#### **Lorimer Road Petition Project**

#### Public Meeting

August 28, 2017

#### **Eliminated Ditches**

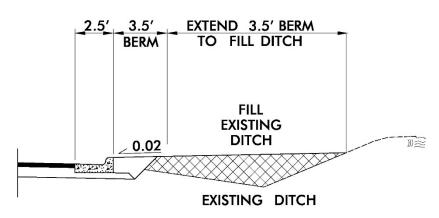
- Reduce sidewalk setback & construction footprint
- Tree Loss & Property Value Loss from construction
- Hire an Arborist to assess impact to trees
- Eliminate existing roadside ditches
- No level spreaders, save trees
- Special Considerations (driveways & walls)

- Extended 3.5' Berm To Fill Existing Ditches
- Eliminated Rock Lined Ditches
- Use Erosion Control Matting for Toe Protection
- Eliminated level spreaders
- Direct discharge to Bushy Creek from new storm system (same as existing)
